Reed Subdivision

Environmental Review Team Report

ENVIRONMENTAL REVIEW TEAM REPORT ON REED SUBDIVISION COLCHESTER, CONNECTICUT

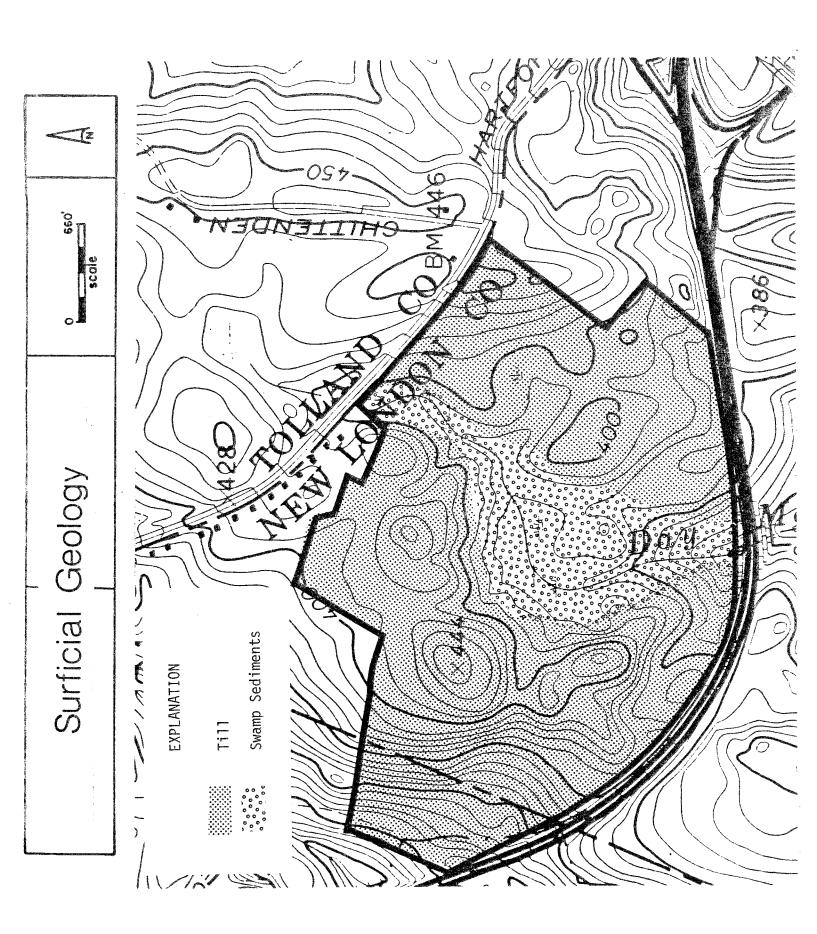
Based on the site plan submitted to team members on the field review day, the proposed interior road system calls for four wetland crossings. Additional crossings of wetland soils by driveways may also be required, depending on the final project layout. Although undesirable, wetland road crossings can be feasible when they are properly engineered.

When crossing wetland soils with roads or driveways, provisions should be made for removing unstable material beneath the road bed, backfilling with a permeable road base fill material, and installing culverts as necessary.

The roads should be at least 1.5 feet and preferably 2 feet above the surface elevation of wetlands. This will allow for better drainage of the roads. It will also decrease the frost heaving potential of the road. Road construction through wetlands should preferably be done during the dry time of the year and should include provisions for effective erosion and sediment control. It is particularly important that culverts be properly sized and located so as not to alter the water levels in the wetland.

Drainage Areas

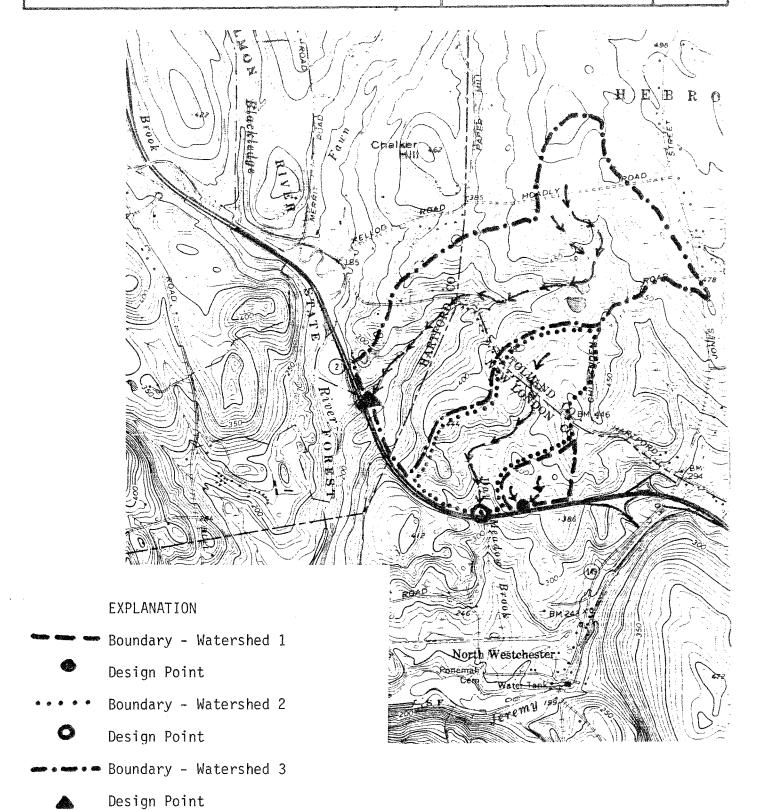
As shown by the accompanying Drainage Area map, the parcel can be divided into three watershed areas. Surface runoff from approximately 32 acres in the eastern portion of the site drains towards a culvert passing under Route 2 at the southern boundary. Once the water passes under Route 2 it flows generally southward until it finally merges with Day Meadow Brook. Drainage in the central parts of the site flows downslope into Day Meadow Brook, which bisects that portion of the property. Day Meadow Brook passes through a culvert under Route 2 and ultimately discharges into Jeremy River south of the property. Finally, surface drainage in the western parts of the property flows generally westward towards an unnamed tributary to Blackledge River.

design point and its corresponding watershed was chosen. Those design points or points of outflow are shown on the Drainage Area map. It should be pointed out that the project engineer may analyze runoff differently since there are several other methods available for estimating the amounts of increased runoff, i.e., rational method, etc.

The results of the Team Geologist's calculations, shown below for each design point chosen, should be considered as "ball park" figures with regard to the estimated peak flows and runoff volumes. The calculated percentages of increase should be fairly close, however.
